# Access Compliance Report

## Public Rights-of-Way

### (Curb Ramps)

Intersection ID: 7758	Main Street: EAGLE_PEAK_DR	Cross Street: GLENMOOR_DR	Location: W
ADA ID: 8713DC0552B0	Ramp Type: Perp	Initial Pass/Fail: Fail	Overall Compliance: No
		Severity Score: 22.5

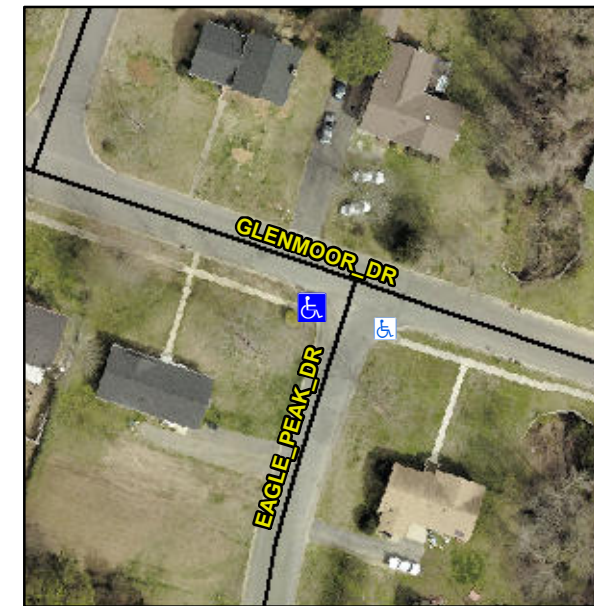
**Not Found, R304.5.1, R304.2.2, R304.5.3**

Compliance	Description	Data	Compliance	Description	Data
N/A	Ramp Length (in)	40.0	No	Ramp Slope (%)	9.2
No	Ramp Width (in)	44.5	No	Ramp XSlope (%)	4.3
N/A	Flare Type LT	N/A	N/A	Flare Type RT	N/A
N/A	Flare Slope LT (%)	N/A	N/A	Flare Slope RT (%)	N/A
N/A	Flare Traversable LT?	N/A	N/A	Flare Traversable RT?	N/A
N/A	Landing Length (in)	N/A	N/A	DWS Provided?	N/A
N/A	Landing Width (in)	N/A	N/A	DWS Contrast?	N/A
N/A	Landing Slope (%)	N/A	N/A	DWS Length (in)	N/A
N/A	Landing X Slope (%)	N/A	N/A	DWS Full Width?	N/A
N/A	Landing Curb? (Y/N)	N/A	N/A	DWS Offset (in)	N/A
N/A	Shared Landing?	N/A			
N/A	Gutter Ponding?	N/A	N/A	Gutter Slope (%)	N/A
N/A	Gutter Lip Ht (in)	N/A	N/A	Gutter X Slope (%)	N/A
N/A	Painted X Walk1?	No	N/A	Painted X Walk2?	N/A
	X Walk 1 Direction	To SE		X Walk 2 Direction	N/A
N/A	X Walk 1 Width (in)	N/A	N/A	X Walk 2 Width (in)	N/A
	X Walk 1 Slope (%)	0.9		X Walk 2 Slope (%)	N/A
	X Walk 1 X Slope (%)	2.3		X Walk 2 X Slope (%)	N/A

**Remove & Replace Entire Ramp.**
